Subject: UniStar Nuclear Energy, NRC Docket No. 52-016
Response to Request for Additional Information for the
Calvert Cliffs Nuclear Power Plant, Unit 3,
RAI No. 304, Seismic System Analysis

**Response to NRC Request for Additional Information
RAI No. 304, Question 03.07.02-54,
Seismic System Analysis,
Calvert Cliffs Nuclear Power Plant, Unit 3**

Question 03.07.02-54

**FIGURE 1.
WEST-HALF MODEL OF THE CBIS**

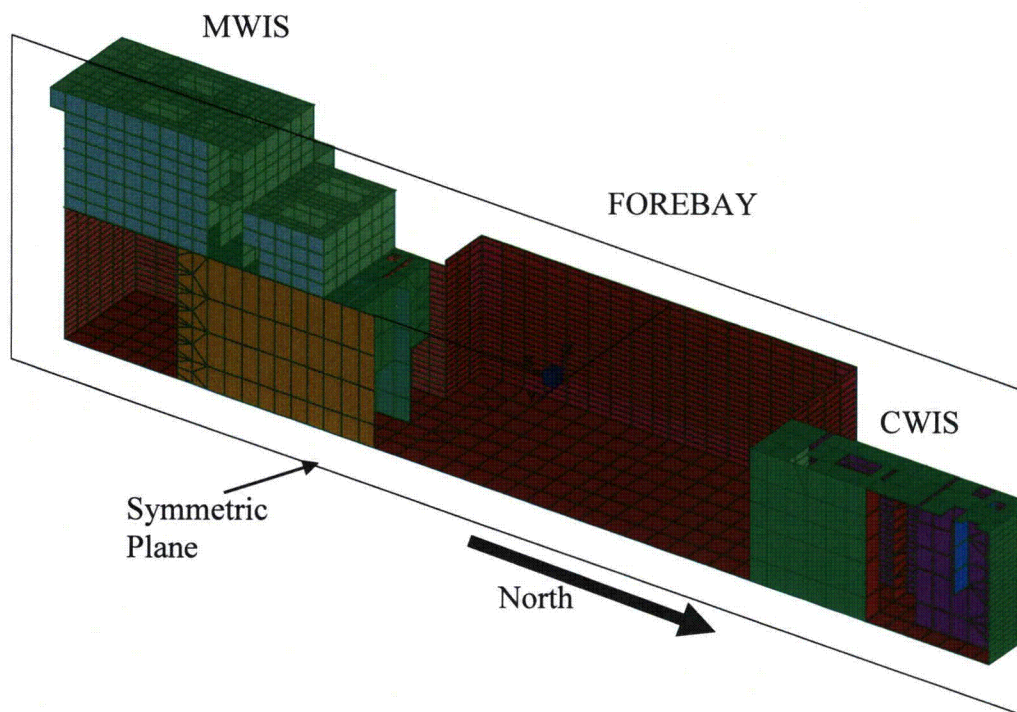
1. Provide for the horizontal directions the soil model mesh size for elevations both above and below elevation -27.5 feet and their technical basis.
2. Provide the basis for the mesh size in the vertical direction below elevation -27.5 feet.
3. Resolve the discrepancy between the mesh size of 1.5 feet and 1.6 feet.
4. Demonstrate, as originally requested, whether the dynamic structural model is sufficiently detailed such that further refinement will have a negligible effect on the solution results.

The Common Basemat Intake Structures (CBIS) at Calvert Cliffs Nuclear Power Plant (CCNPP) Unit 3 include the Makeup Water Intake Structure (MWIS), the Forebay, and the Circulating Water Makeup Intake Structure (CWIS). Previously, a Seismic Soil Structure Interaction (SSI) analysis was performed on the CBIS to evaluate the seismic response of the structures using a model that included only the western half of the CBIS, as shown in Figure 1. RIZZO's SASSI program version 1.3a is used for the SSI analysis.

located at the positions of the soil layer interfaces. Hence, the mesh size in the vertical direction for the structural elements (Figure 1) is equal to the adjacent soil layer thicknesses (Figure 2).

The SSI model of the CBIS uses a relatively fine mesh in the MWIS area, while the mesh in the Forebay and CWIS areas is relatively coarse, as shown in Figure 1 and Figure 2. The mesh used for the excavated soil is based on an aspect ratio of about 3.5 and 4.0 in plan in the MWIS and Forebay regions, respectively. The aspect ratio referred to here is the ratio of maximum to the minimum dimension of a solid element.
